OFFICE OF RATEPAYER ADVOCATES
CALIFORNIA PUBLIC UTILITIES COMMISSION

DIRECT TESTIMONY

**APPLICATION OF SOUTHERN CALIFORNIA EDISON COMPANY
FOR A CERTIFICATE OF PUBLIC CONVENIENCE AND NECESSITY
FOR THE ALBERHILL SYSTEM PROJECT**

**APPLICATION OF SOUTHERN CALIFORNIA EDISON COMPANY
FOR A PERMIT TO CONSTRUCT ELECTRICAL FACILITIES WITH
VOLTAGES BETWEEN 50KV AND 200KV: VALLEY-IVYGLEN 115
KV SUBTRANSMISSION LINE PROJECT**

Figure 1 Existing Valley South System

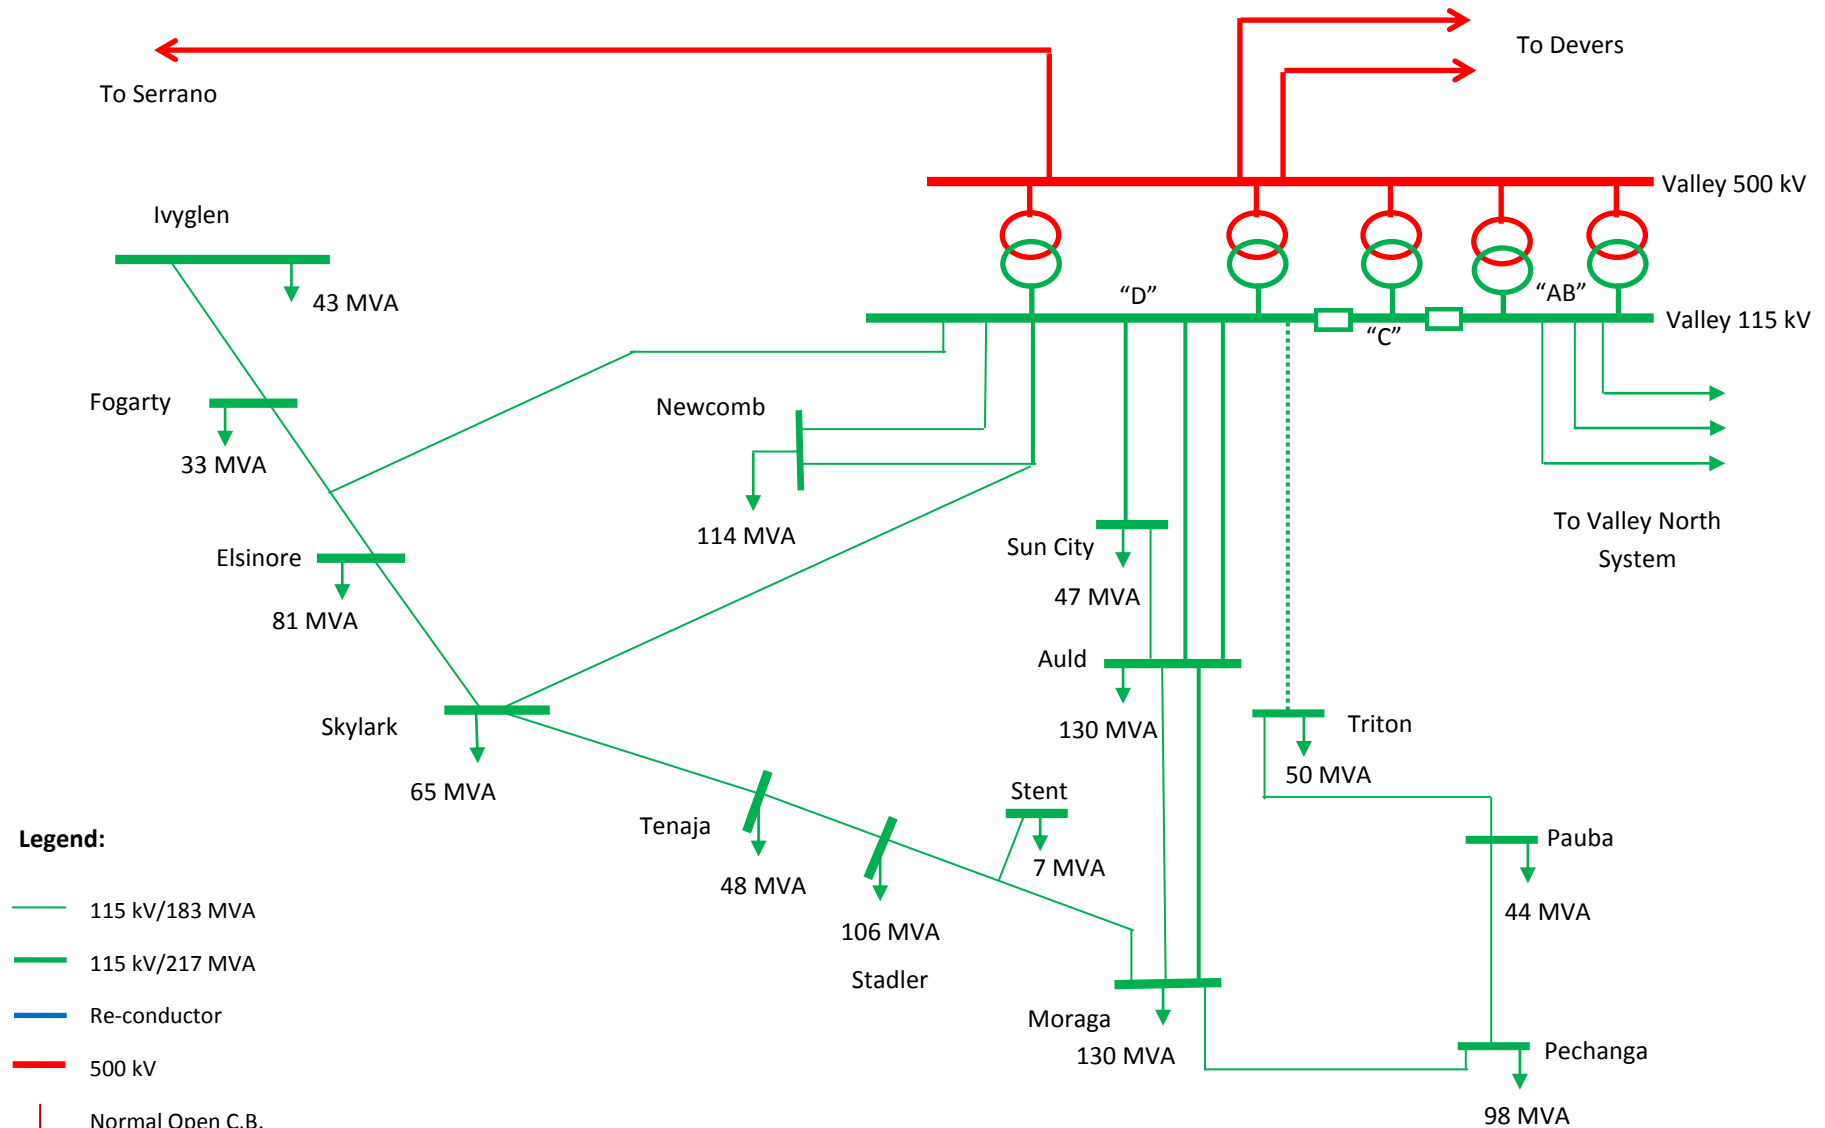
As shown in Figure 1 in Appendix C, the Valley Substation currently contains five transformers, each with a capacity of 560 megavolt-amps (MVA), to step down electric power voltage from the 500 kilovolt (kV) bus to 115 kV bus. The 115 kV bus is divided into three sections:

- 1) Section “AB,” with two 560 MVA transformers, serves the Valley North System;
- 2) Section “C,” with one spare 560 MVA transformer, does not serve any load; and
- 3) Section “D,” with two 560 MVA transformers, serves the Valley South System.

Figure 3 Option 1: Loop in Fogarty and Ivyglen Substations

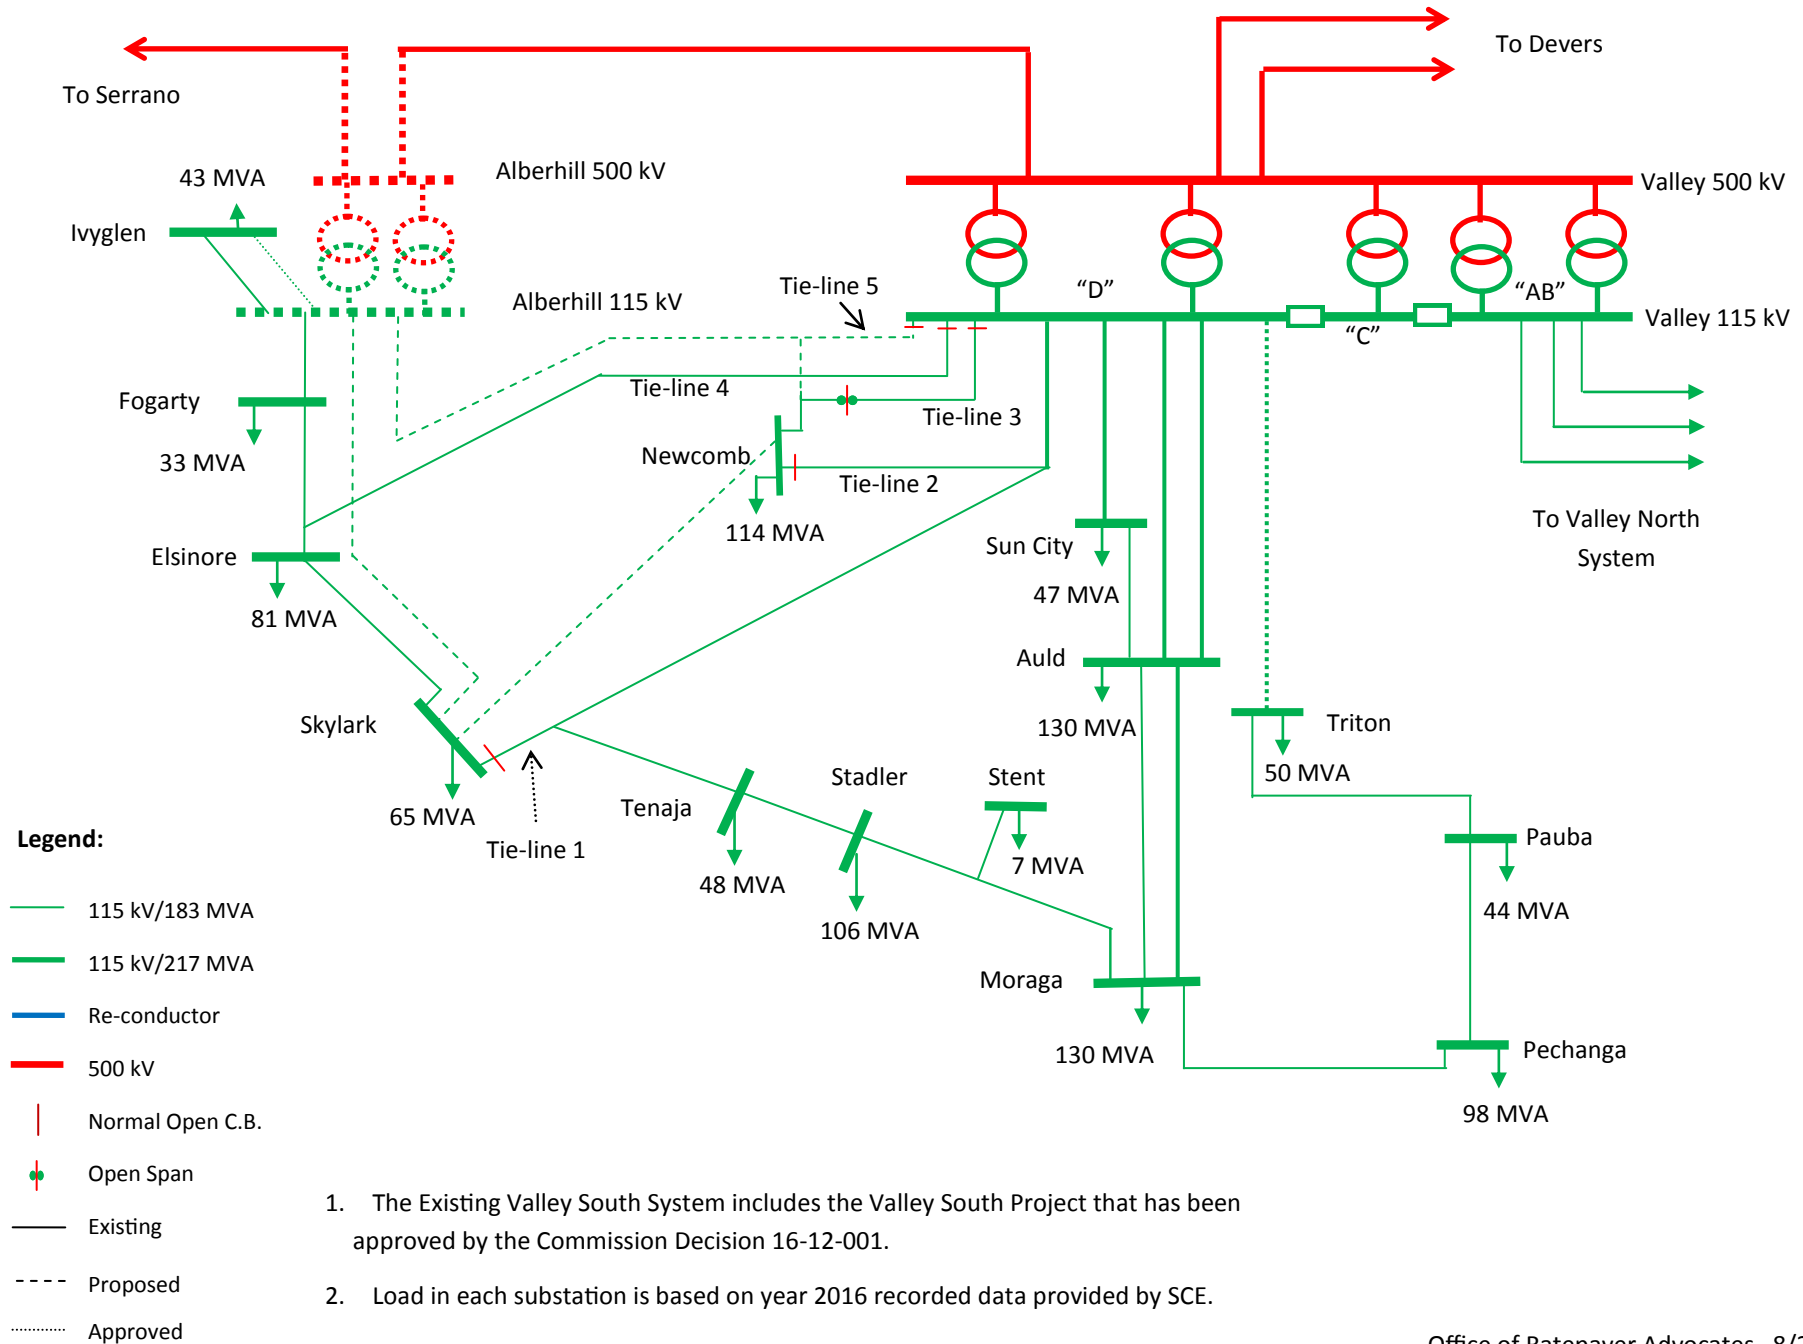
Among the 14 substations¹⁸ in the Valley South System, Ivyglen and Fogarty Substations are served radially – they have only one source line. If the Fogarty leg of the Valley-Elsinore-Fogarty three-terminal line is interrupted, both Ivyglen and Fogarty Substations will lose power completely. In order to improve the power supply flexibility and reliability for these two substations, ORA proposes Option 1 as illustrated in Figure 3 in Appendix C. The Commission can order SCE to construct the following components:

- 1 1. Re-conductor the Valley leg of the Valley-Fogarty-Elsinore
2 three-terminal line to higher capacity, disconnect this leg from
3 the tap point, and extend it to Ivyglen Substation, so this leg will
4 become the Valley–Ivyglen line, looping in the Fogarty and
5 Ivyglen Substations. Since this line is approximately 27 miles
6 long, SCE should use conductors that have low resistance and
7 inductance to minimize voltage drop on this line.
- 8 2. Re-conductor the Valley leg and Skylark leg of the
9 Valley-Skylark-Newcomb three-terminal line to carry power for
10 Newcomb, Skylark and Elsinore substations, SCE should ensure
11 these two legs have sufficient power transfer capability.

Figure 4.2

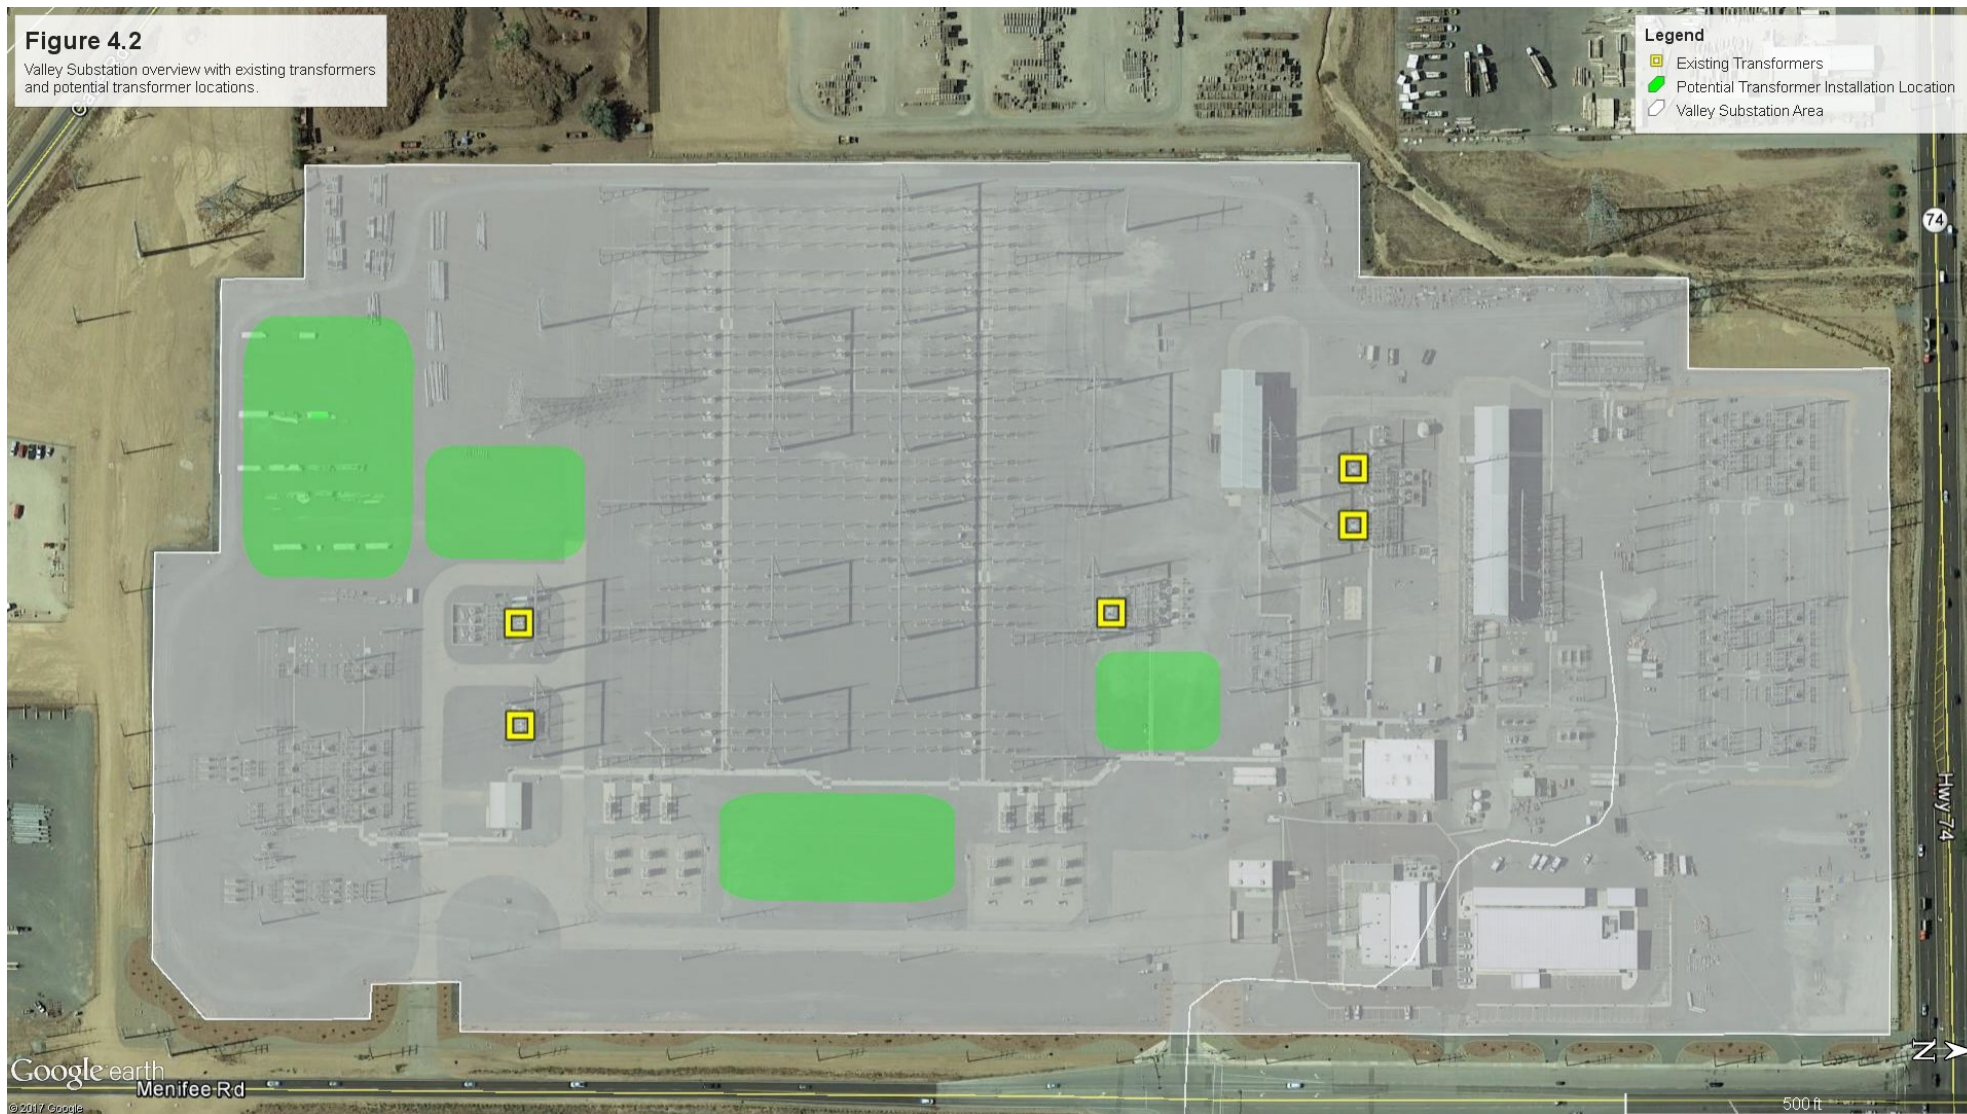
12 The Valley Substation has sufficient physical space for a sixth transformer. Based
13 on ORA’s preliminary analysis that was subsequently confirmed by a December 7, 2016
14 site visit to the Valley Substation, ORA identified multiple on-site locations where a sixth
15 transformer could be located and space limitations within the substation do not appear to
16 be a concern. Figure 4.2 in Appendix C presents a sketch of potential transformer
17 locations. Additionally, the Valley Substation is not in a highly developed area and there
18 are lightly- or undeveloped parcels to the east, south, and west of the station. Therefore,
19 SCE may have options to build in the underdeveloped parcels if the Commission does not
20 authorize the installation of a sixth transformer within the existing Valley Substation

Figure 5 Option 3: Construct Alberhill Substation without Two Proposed Components

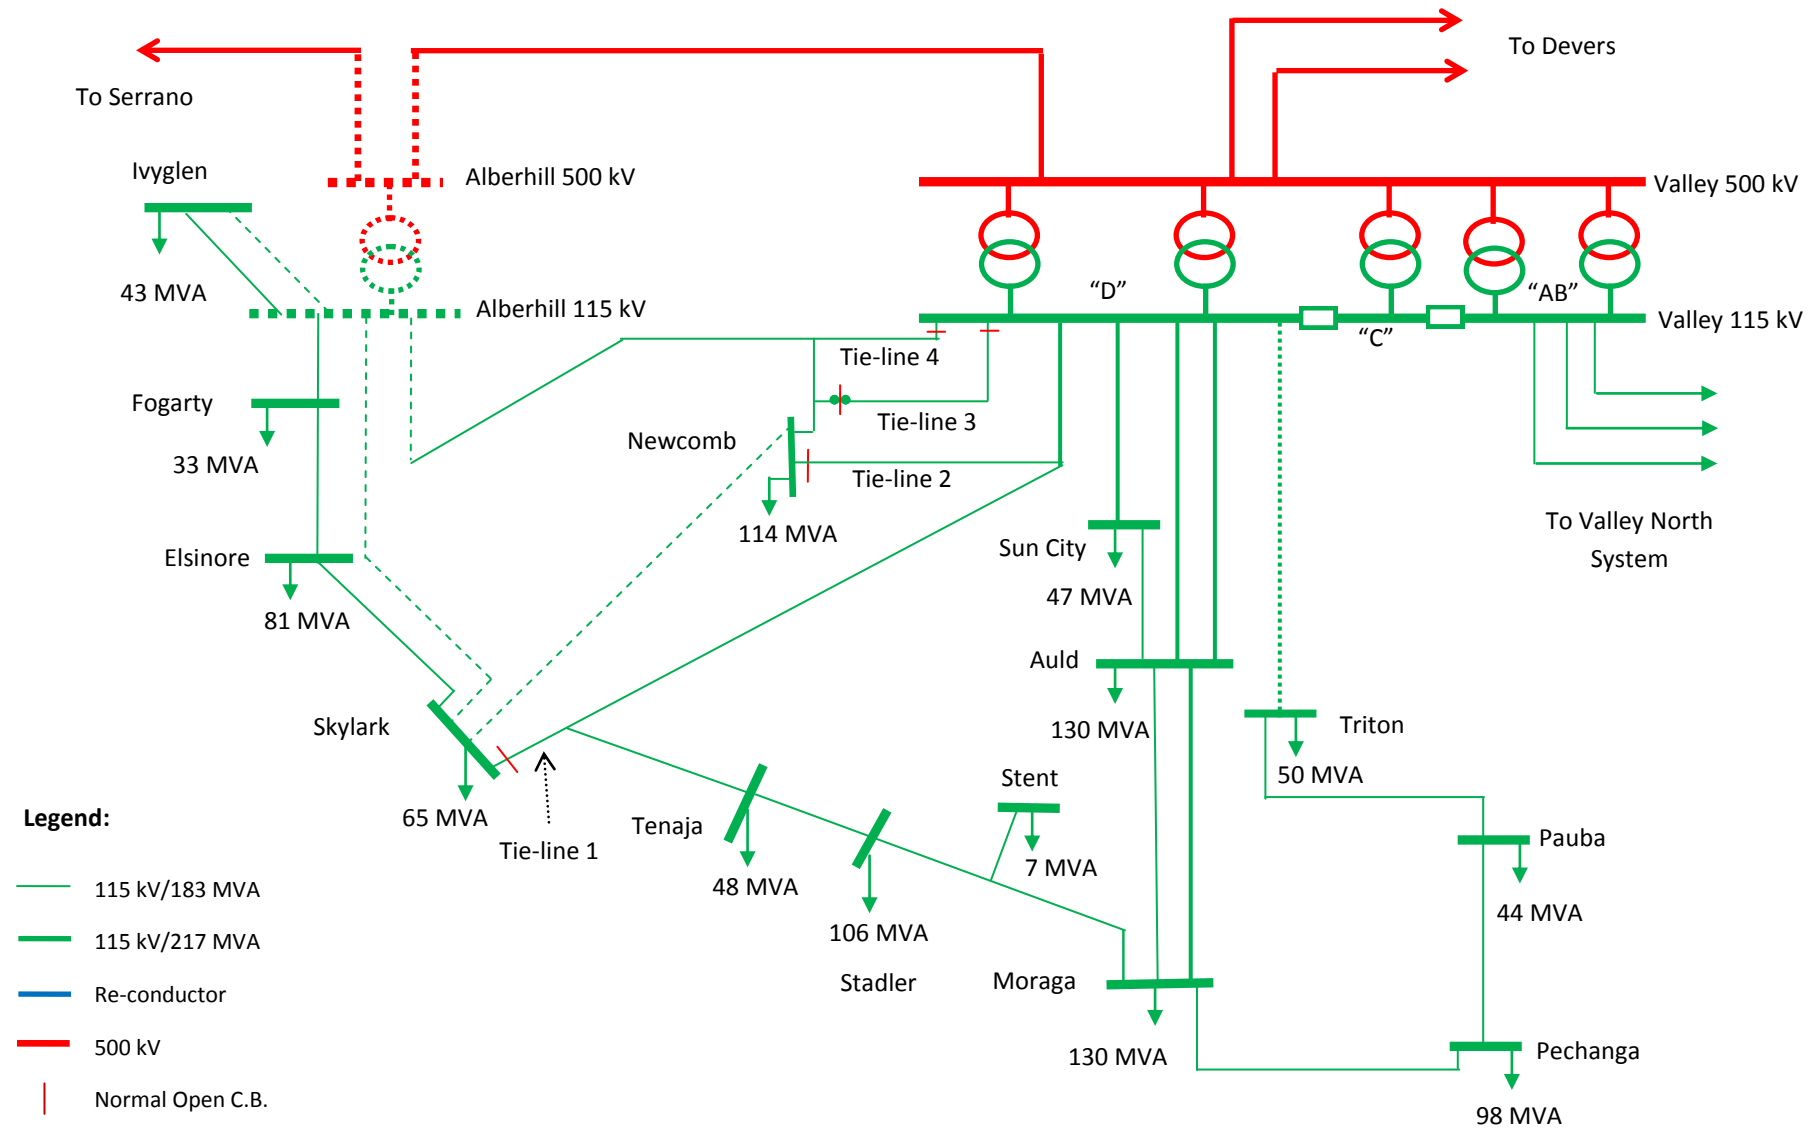
9 However, if the Commission ultimately determines that the Alberhill Substation
10 must be constructed, ORA proposes to eliminate the following two components from
11 SCE's proposed projects:

- 12 1) Installation of the second transformer at the Alberhill Substation;
- 13 2) Construction of the second Valley leg of the Valley-Elsinore-
14 Fogarty three terminal line, approximately 13 miles.

15 After eliminating the above two components, there would be four tie-lines
16 between the Alberhill System and the Valley South System, so there would be no need
17 for the second transformer at Alberhill Substation as proposed by SCE. If the operating
18 transformer at Alberhill Substation is out of service, SCE could restore power supply to
19 the five substations through the tie-lines. These tie-lines would maintain the power
20 supply flexibility and reliability for both the Alberhill System and the Valley South
21 System. Figure 5 in Appendix C illustrates the remaining components after the two SCE-
22 proposed project components are eliminated.
